DEPARTMENT OF HAWAIIAN HOME LANDS
STATE OF HAWAII

ADDENDUM NO. 2

**PAPAKOLEA SUBDIVISION SEWER IMPROVEMENTS
SEWER LINES E, F, L, A, C, D AND K-3 IMPROVEMENTS**

IFB-17-HHL-010

**TRAFFIC CONTROL PLAN - 1
 SEWER LINE "A"
 SMH 318567 TO SMH 318502
 (24-HOUR)**

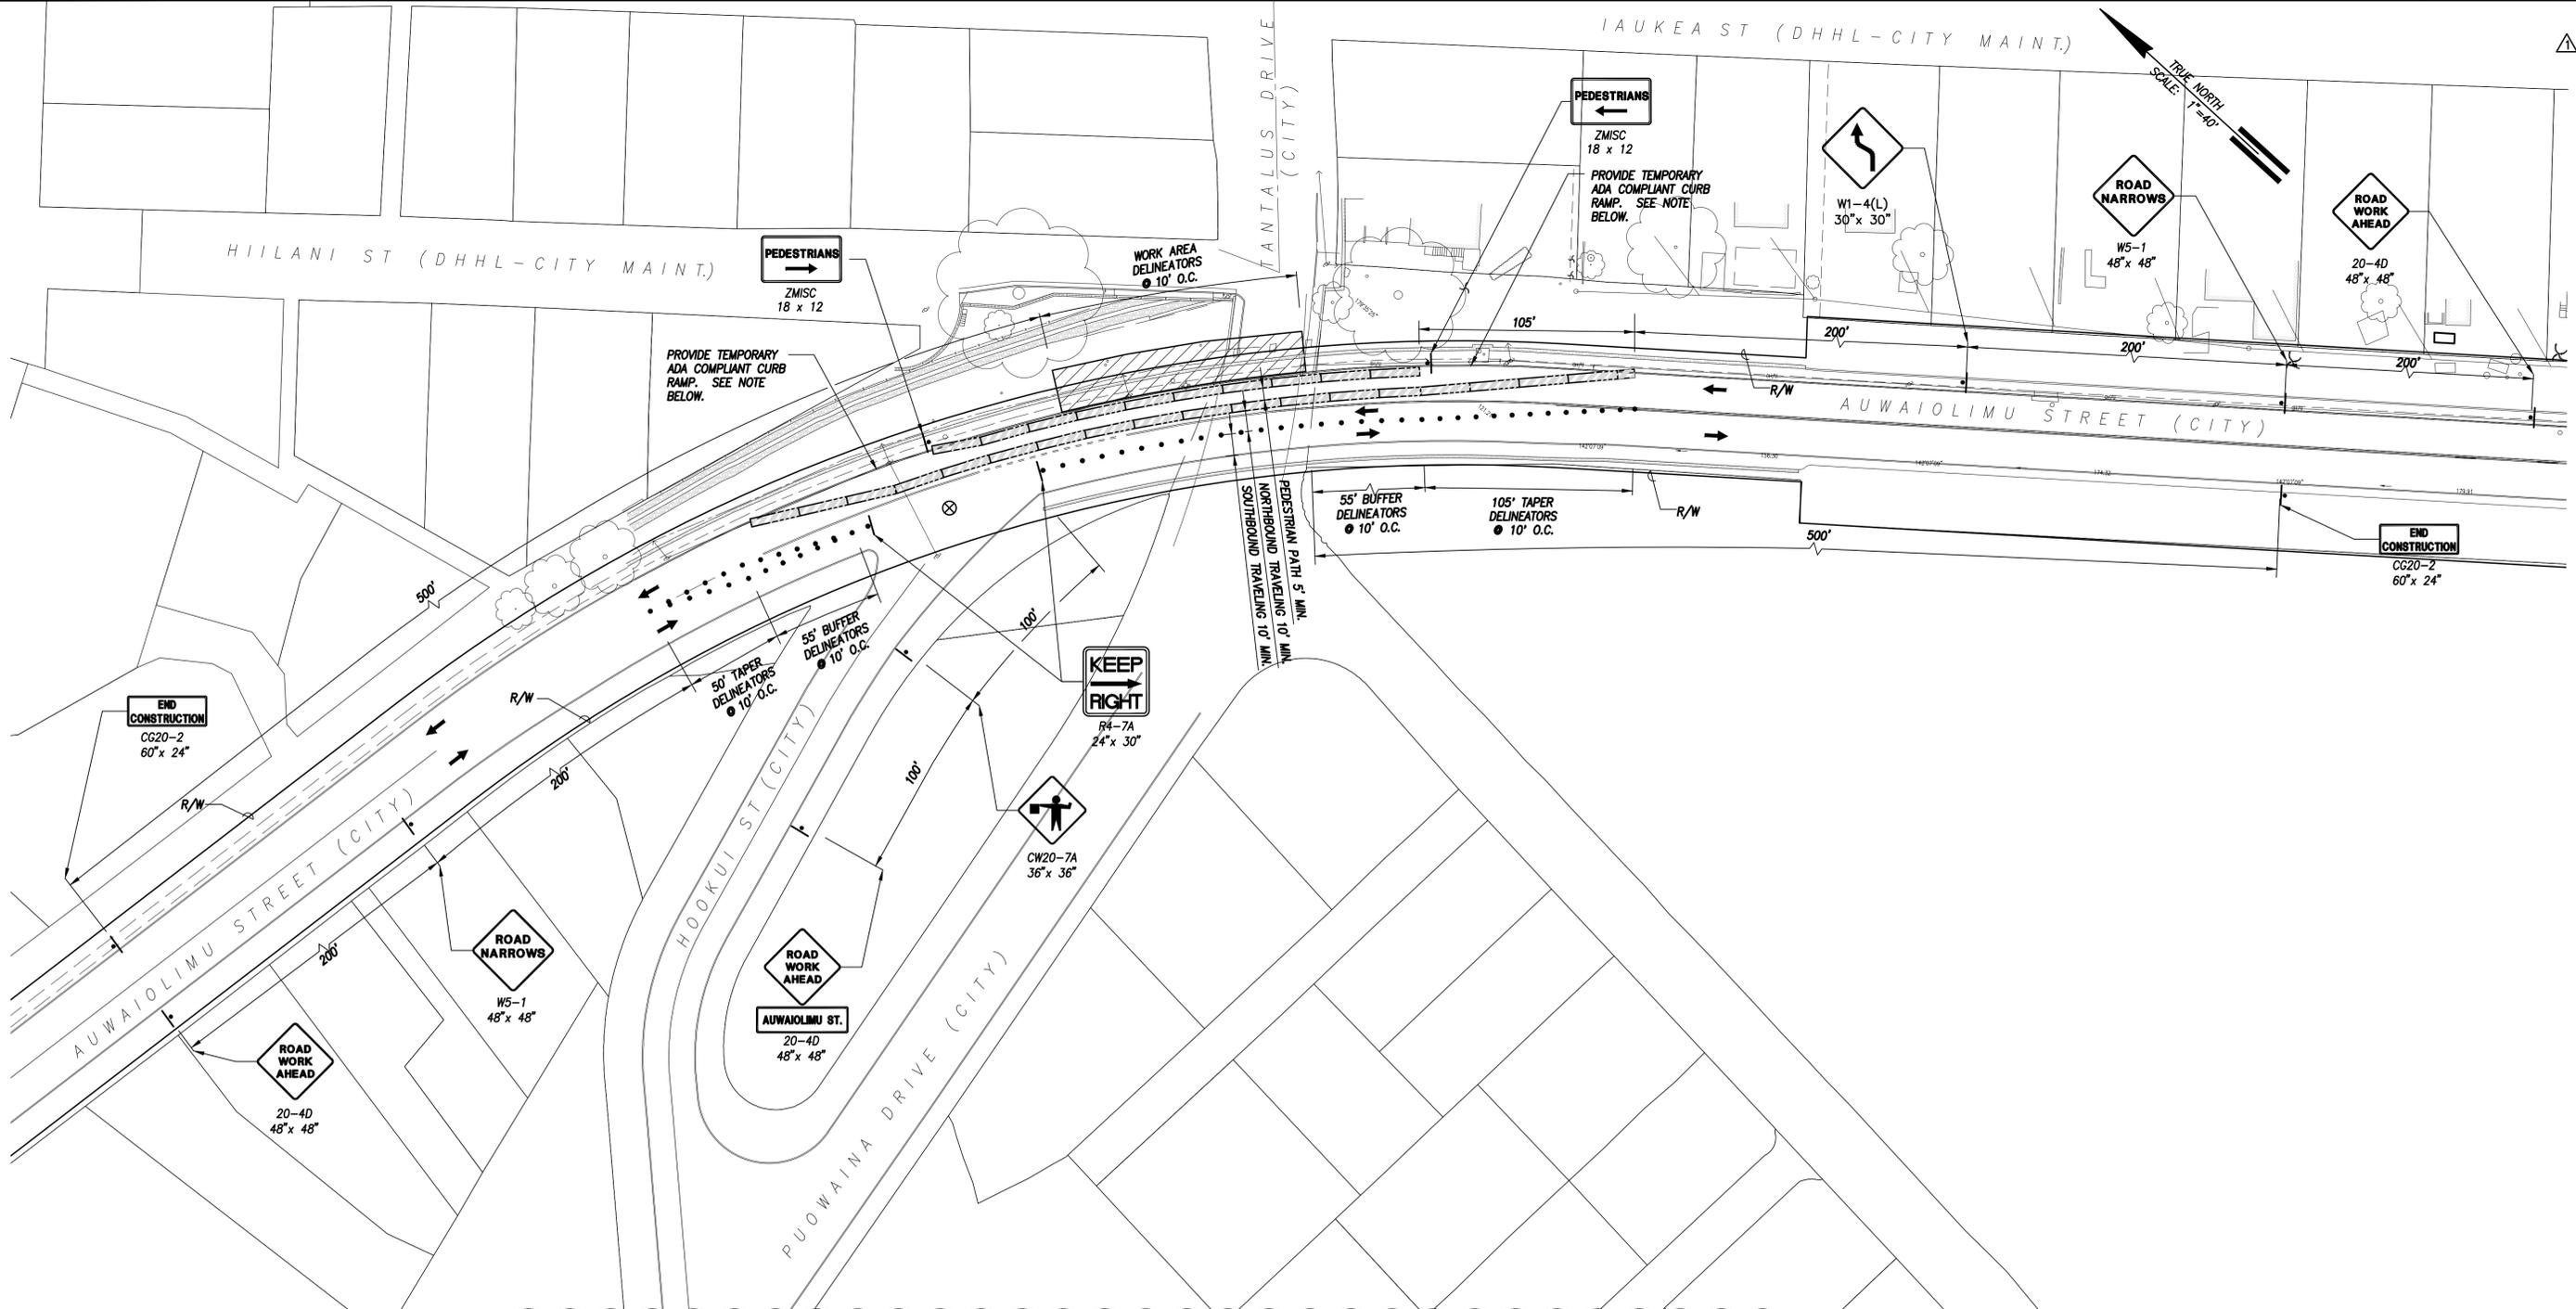
10. Sheet C-29 – “Traffic Control Plan - 1 Sewer Line A - 24-Hour”
 - a. Revised traffic control plan title to clarify work hours.
 - b. Added barricade description in legend.

ENGINEER	AM/JB	REVISION	DATE	BRIEF	BY	APPROVED
DRAFTSMAN	SF	3/27/17	ADD 2: TITLE AND LEGEND	AM	DHHL	
CHECKED BY	AM

TRAFFIC CONTROL PLAN - 2
SEWER LINE "C"
SMH. C1 TO SMH. 318642
(24-HOUR)

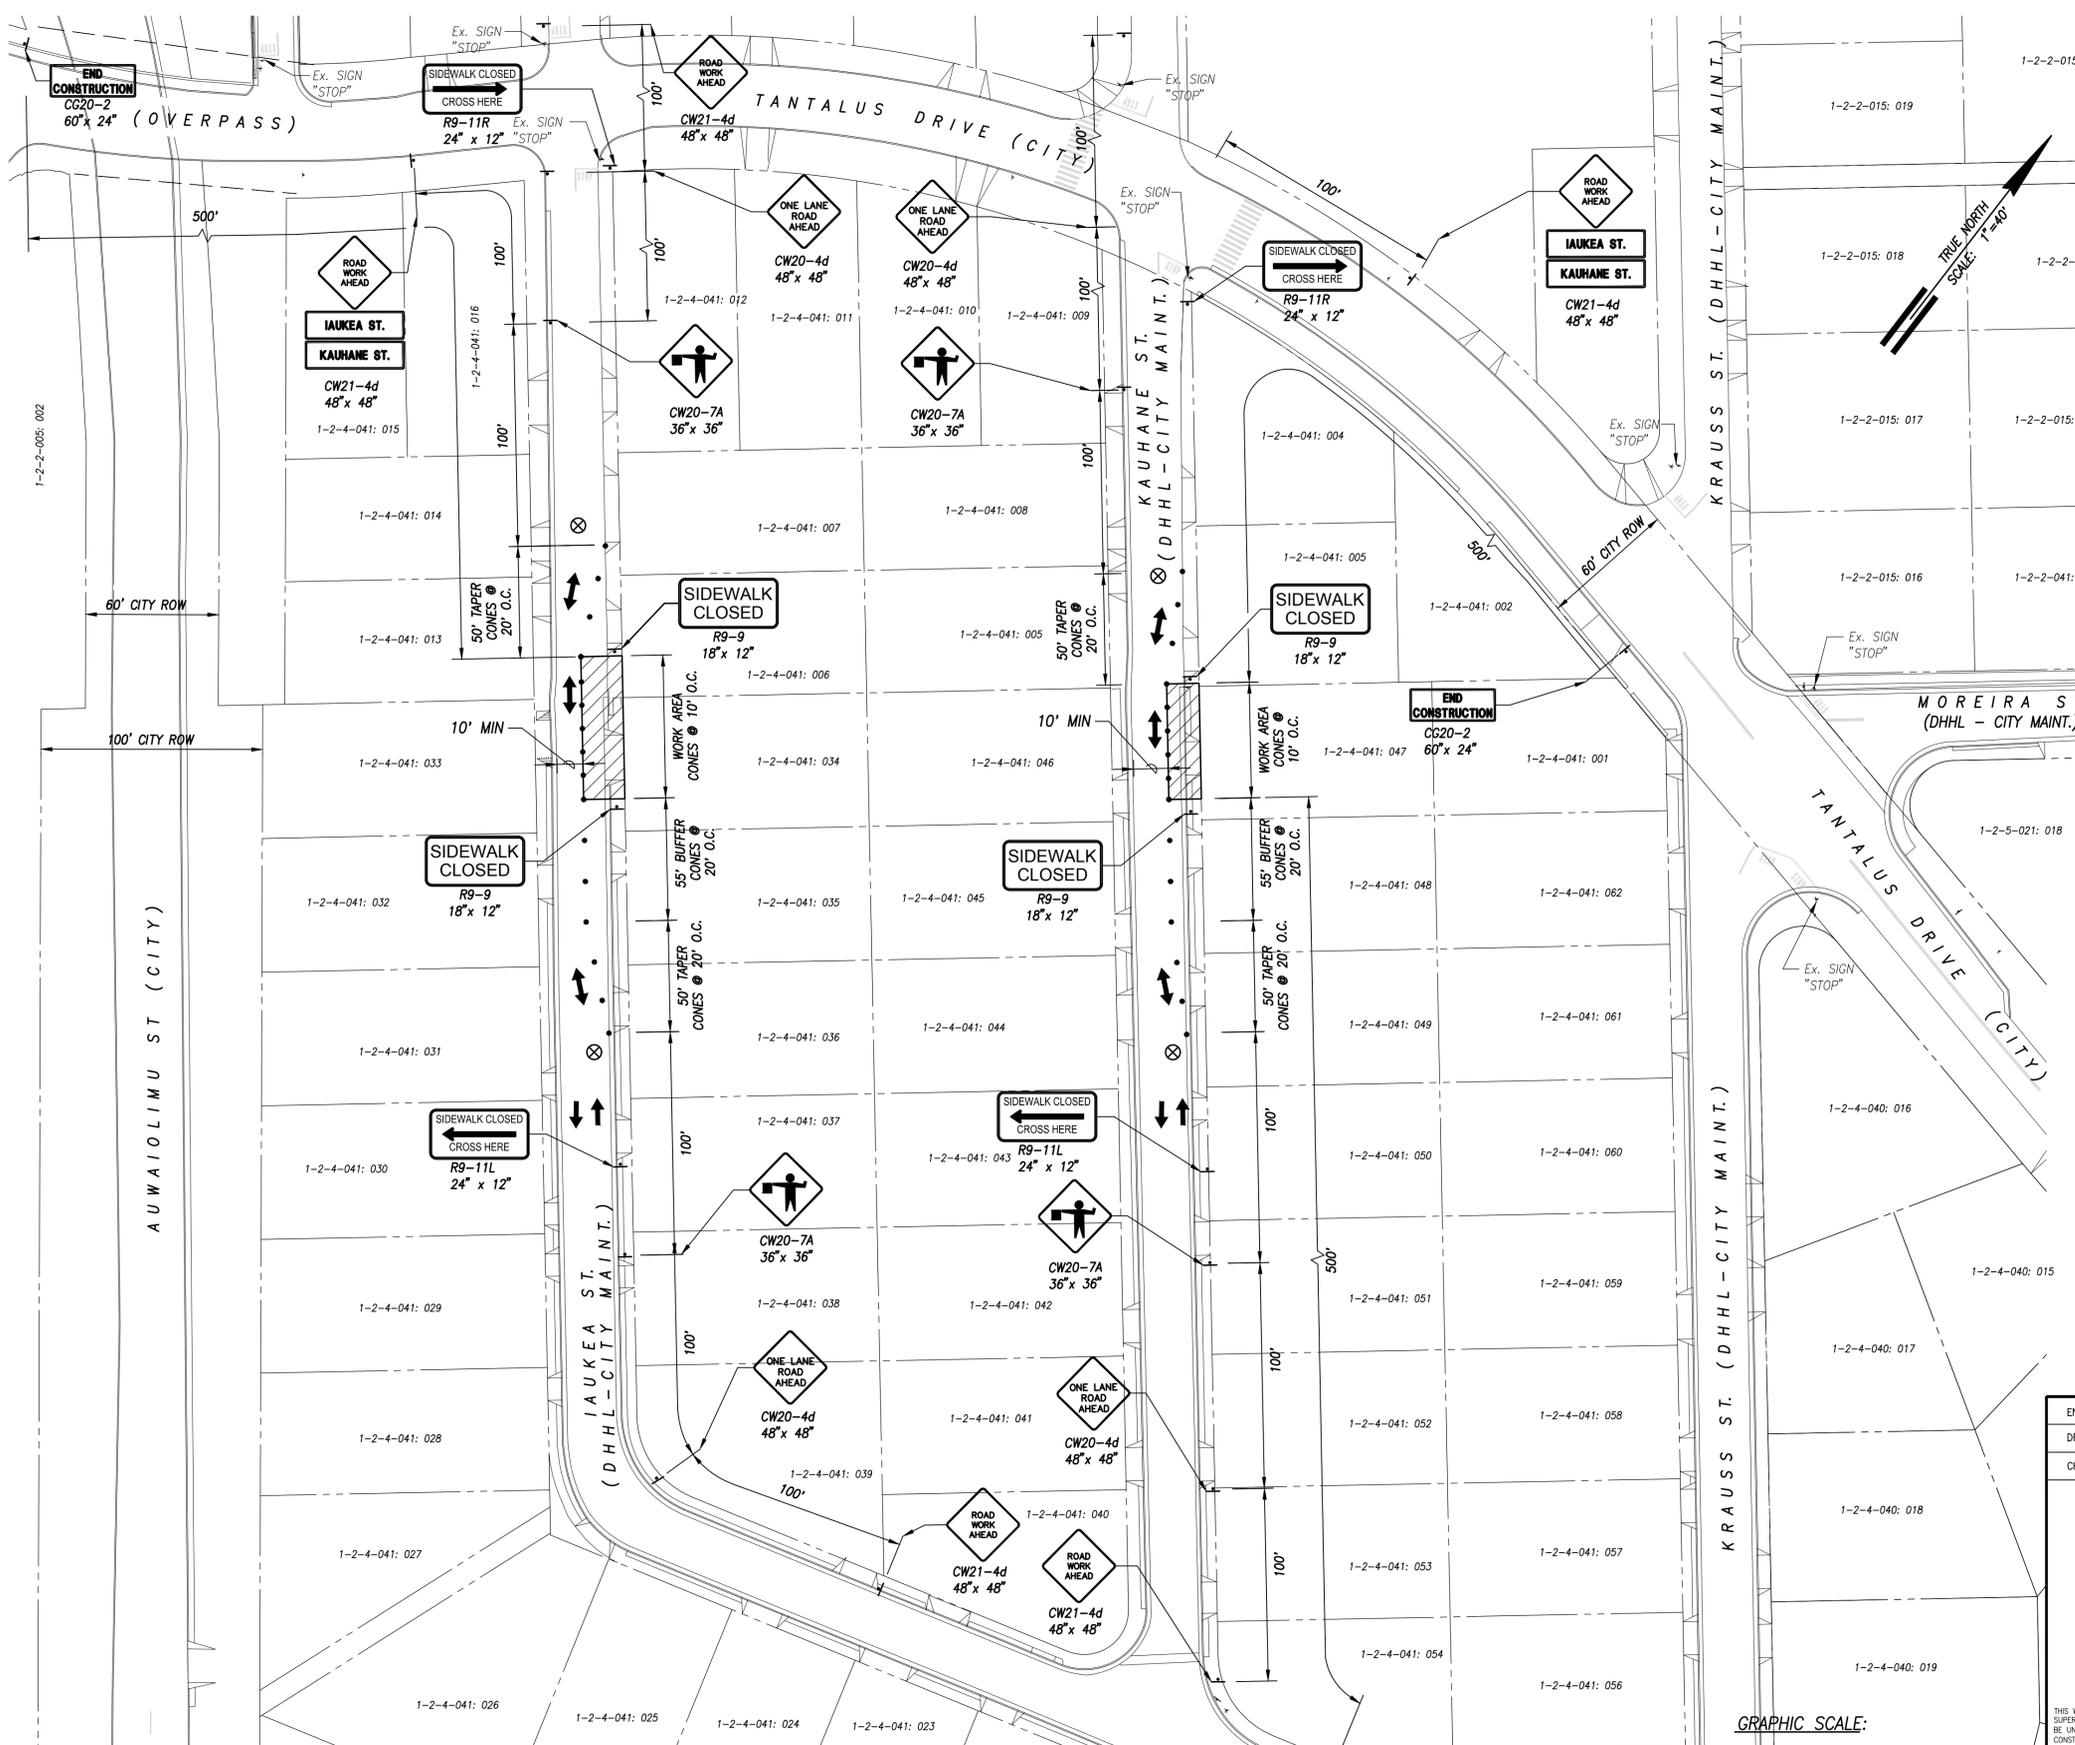
11. Sheet C-30 – “Traffic Control Plan - 2 Sewer Line C SMH C1 to SMH 318642 - 24-Hour”
Revised traffic control plan.
12. Sheet C-31 – “Traffic Control Plan - 3 Sewer Line C SMH 318642 to SMH 318544 - 24-Hour”
Revised traffic control plan.

TRAFFIC CONTROL PLAN - 6
SEWER LINE "D"
SMH. 318812 TO SMH. 318759
(24-HOUR)

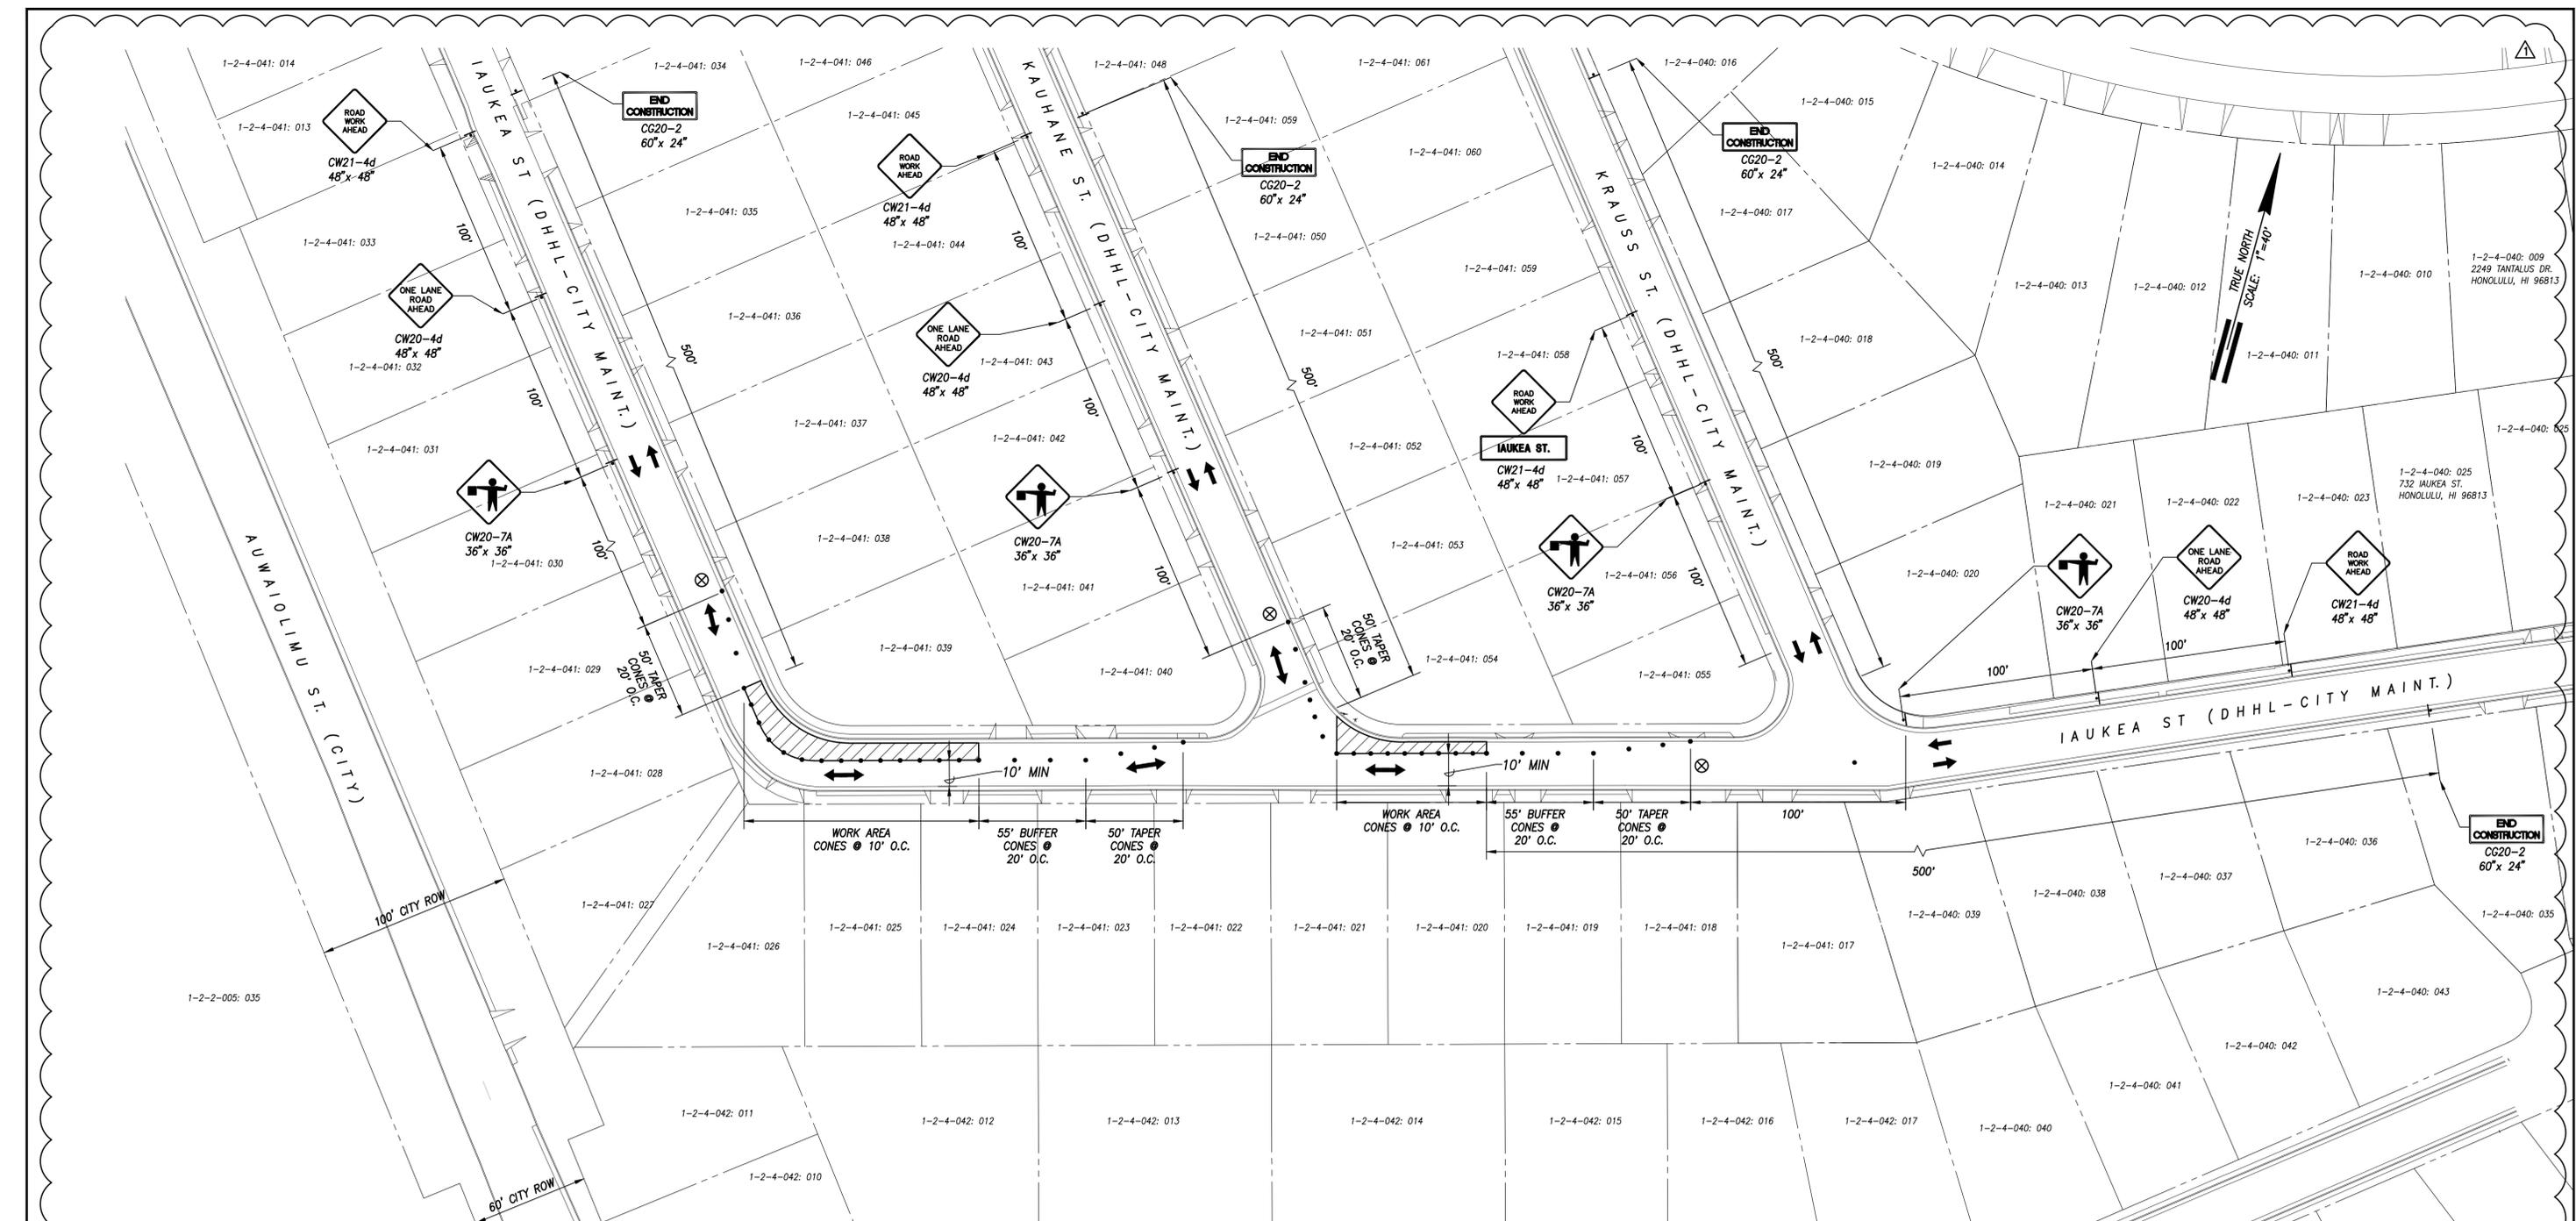
15. Sheet C-34 – “Traffic Control Plan - 6 Sewer Line D SMH 318812 to SMH 318759 - 24-Hour”
Revised traffic control plan.
16. Sheet C-35 – “Traffic Control Plan - 7 Sewer Line D SMH 318759 to SMH 318741 - 24-Hour”
Revised traffic control plan.
